1-**A/ 3-**A Copper Faucet Riser - One-Piece with Insert

Project Name: Webster University-**ISB**

Item No.	Description	No. of Copies	Date
1	Shop Drawing Review – 22 4216.16 Commercial Sinks	1	06-05-2016

SPEC SECTION: 22 4216.16
Commercial Sinks

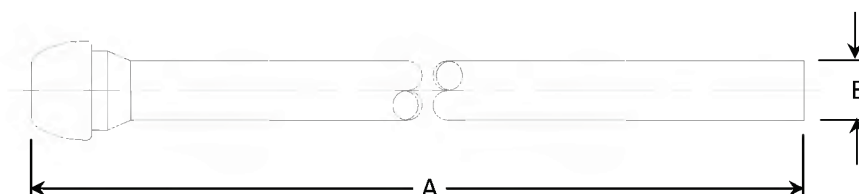
X					Supply Risers BrassCraft Model 1-12AC	
	X				Escutcheons Proflo Model PFE7	Escutcheons are specified to be cast brass. Refer to specification section 220518.
Sink SK-3						
					Fixture	Sink is integral with the countertop. Coordinate with architectural drawings.
X					Faucet Chicago Faucet Model 786-GN2BVBE3-2ABCP	Provide under counter waste and supply protective piping covers as required. Verify requirements with the architectural drawings.
X					Drain Assembly Elkay Model LK35	
X					P-Trap Proflo Model PFPTB403	
X					Angle Stops BrassCraft Model SCR19XC	
X					Supply Risers BrassCraft Model 1-12AC	
	X				Escutcheons Proflo Model PFE7	Escutcheons are specified to be cast brass. Refer to specification section 220518.
Mop Sink MS-1						
X					Fixture Fiat Model TSB-3000	
X					Faucet Symmons Model S-2490	
X					Hose Bracket Proflo Model PF296	
X					Hose Proflo Model PFSSHE	
X					Mop Bracket Proflo Model PF245
